Access Compliance Report

Public Rights-of-Way

Intersection ID: 24302	Main Street: PRESCOTT_POND_LN	Cross Street: RATHLIN_CT	Location: E
ADA ID: B0B2987B0535	Ramp Type: PerpDiag	Initial Pass/Fail: Fail	Overall Compliance: No
Severity Score: 21.25			
Codes/Mitigation Info/Possible Solution		Field Measurements/Component Compliance

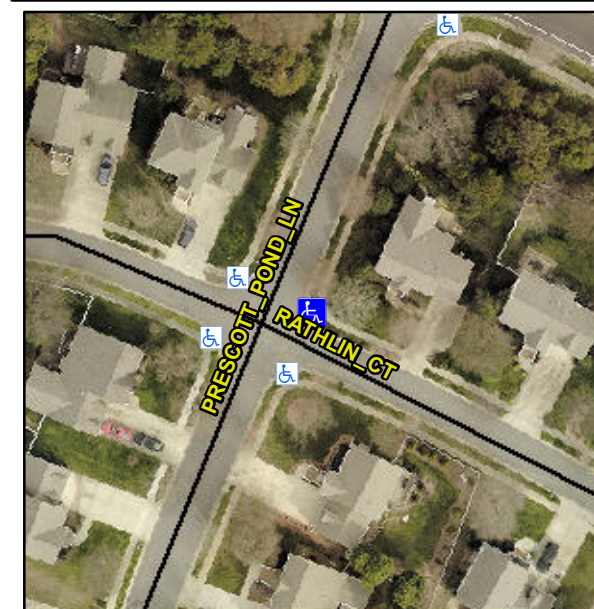
Not Found, R304.5.1, R304.2.2

Compliance	Description	Data	Compliance	Description	Data
N/A	Ramp Length (in)	48.0	No	Ramp Slope (%)	11.2
No	Ramp Width (in)	46.5	Yes	Ramp XSlope (%)	1.0
N/A	Flare Type LT	N/A	N/A	Flare Type RT	N/A
N/A	Flare Slope LT (%)	N/A	N/A	Flare Slope RT (%)	N/A
N/A	Flare Traversable LT?	N/A	N/A	Flare Traversable RT?	N/A
N/A	Landing Length (in)	N/A	N/A	DWS Provided?	N/A
N/A	Landing Width (in)	N/A	N/A	DWS Contrast?	N/A
N/A	Landing Slope (%)	N/A	N/A	DWS Length (in)	N/A
N/A	Landing X Slope (%)	N/A	N/A	DWS Full Width?	N/A
N/A	Landing Curb? (Y/N)	N/A	N/A	DWS Offset (in)	N/A
N/A	Shared Landing?	N/A			
N/A	Gutter Ponding?	N/A	N/A	Gutter Slope (%)	N/A
N/A	Gutter Lip Ht (in)	N/A	N/A	Gutter X Slope (%)	N/A
N/A	Painted X Walk1?	No	N/A	Painted X Walk2?	No
	X Walk 1 Direction	To NW		X Walk 2 Direction	To SW
N/A	X Walk 1 Width (in)	N/A	N/A	X Walk 2 Width (in)	N/A
	X Walk 1 Slope (%)	3.3		X Walk 2 Slope (%)	3.0
	X Walk 1 X Slope (%)	1.2		X Walk 2 X Slope (%)	0.4

Remove & Replace Curb Ramp With Two New Directional Ramps or Equivalent.
